#### NINE MILE POINT NUCLEAR STATION, UNIT 1

#### AMENDMENT TO FACILITY OPERATING LICENSE

Amendment No. 164 License No. DPR-63

## ATTACHMENT TO LICENSE AMENDMENT NO. 164

#### FIGURE 3.2.2.a

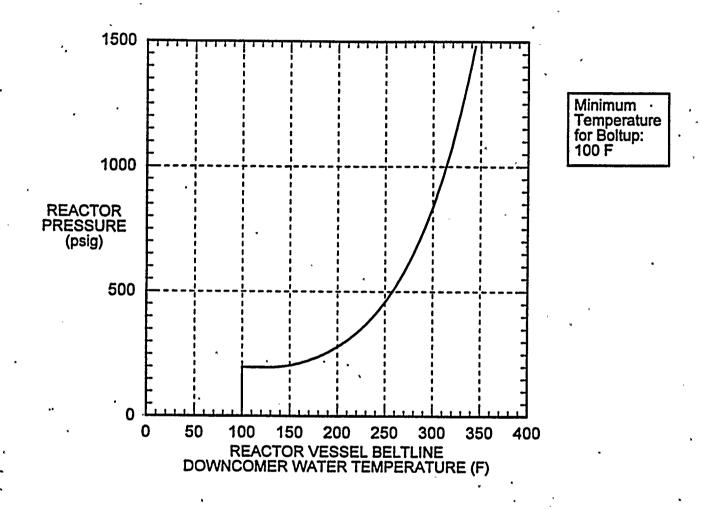
#### MINIMUM BELTLINE DOWNCOMER WATER TEMPERATURE FOR PRESSURIZATION DURING HEATUP AND LOW-POWER PHYSICS TESTS (CORE NOT CRITICAL) (HEATING RATE ≤ 100°F/HR) FOR UP TO 28 EFFECTIVE FULL POWER YEARS OF OPERATION

#### FIGURE 3.2.2.f

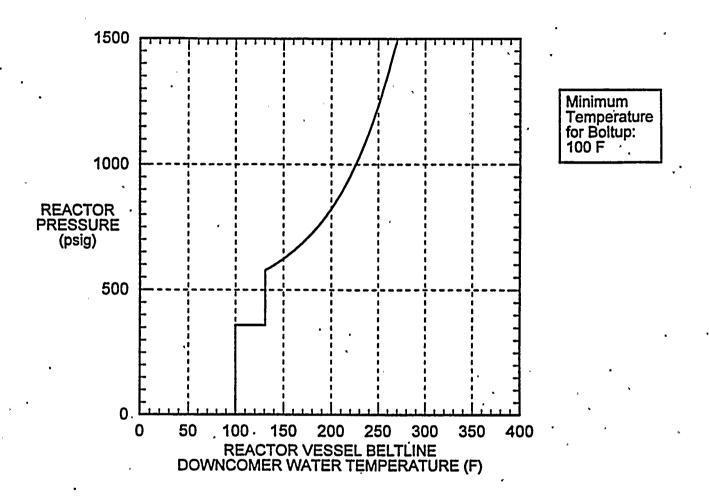
c. During leakage and hydrostatic testing, the reactor vessel temperature and pressure shall satisfy the requirements of Figures 3.2.2.e, 3.2.2.f, or 3.2.2.g, as appropriate, if the core is not critical. During reactor vessel heatup and cooldown for the purpose of leakage and hydrostatic testing, the reactor vessel temperature and pressure shall satisfy the requirements of Figures 3.2.2.a and 3.2.2.b for non-critical heatup and cooldown, respectively.

### MINIMUM BELTLINE DOWNCOMER WATER TEMPERATURE FOR PRESSURIZATION DURING IN-SERVICE HYDROSTATIC TESTING AND LEAK TESTING (CORE NOT CRITICAL) FOR UP TO 20 EFFECTIVE FULL POWER YEARS OF OPERATION

#### FIGURE 3.2.2.g

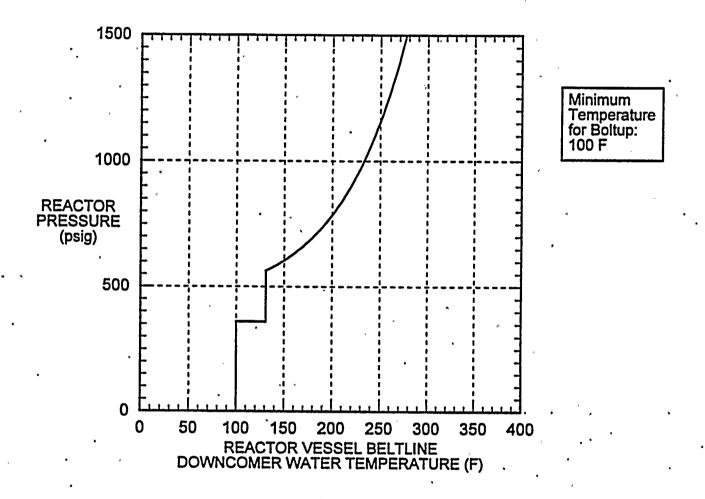
### MINIMUM BELTLINE DOWNCOMER WATER TEMPERATURE FOR PRESSURIZATION DURING IN-SERVICE HYDROSTATIC TESTING AND LEAK TESTING (CORE NOT CRITICAL) FOR UP TO 24 EFFECTIVE FULL POWER YEARS OF OPERATION
